SANSBURY CROSSING

Conceptual Site Plan

Case: CSP-07002-01

PROPOSED CONDITION REVISIONS

SECTOR PLAN VISION: MIXED-USE ACTIVITY CENTERS

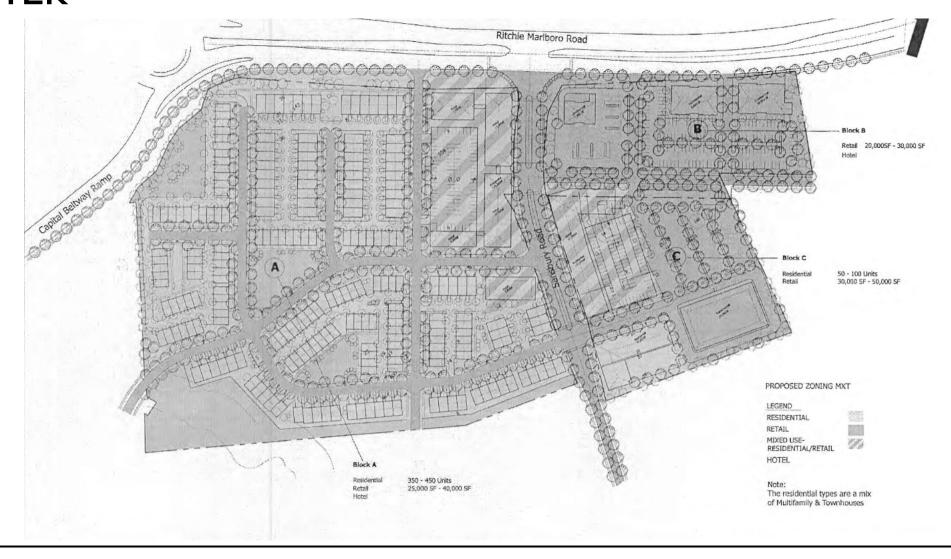
Restrict drive-in commercial services to rear areas behind main structures; do not allow on street fronts.
